# Rezoning Transportation Analysis

Petition Number: 2019-009

## Revision Log:

Date	Description
02-14-2019	First Review
03-18-2019	Second Review

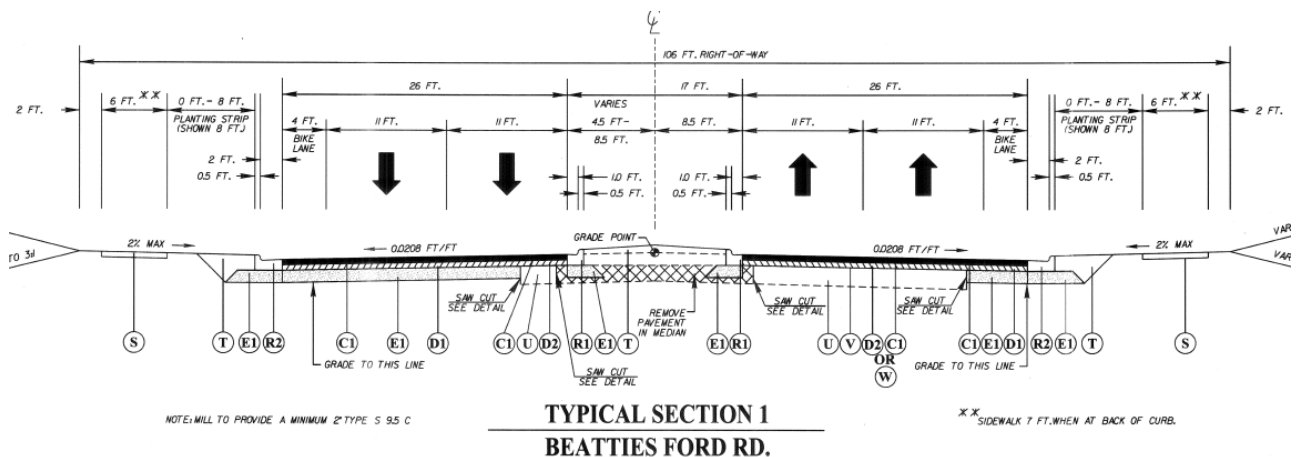
1. **Curbline:** The proposed zoning district has a setback measured from back of proposed future right-of-way line. The location of the future back of curb is as follows:
  - a. **Beatties Ford Road** - future back-curb is 33' as measured from the street's existing centerline. The petitioner shall revise the site plan and conditional note(s) to commit to construct the curb

and gutter. The site plan should label and dimension the future curb and gutter from the centerline of the road. See note 3 for further details.

3. The petitioner should revise the site plan and conditional note(s) to widen Beatties Ford Rd. to include:

- a. An 8-foot planting strip, and 12-foot concrete multi-use path.
- b. Construct 2.5' curb/gutter located 33' as measured from the street's existing centerline and Beatties Ford Rd. pavement widening per City Ordinance, Chapter 19.

- c. The petitioner needs to depict on the Rezoning Conceptual Plan (sheet 1) 60' of right-of-way dedication as measured for the street's existing centerline.
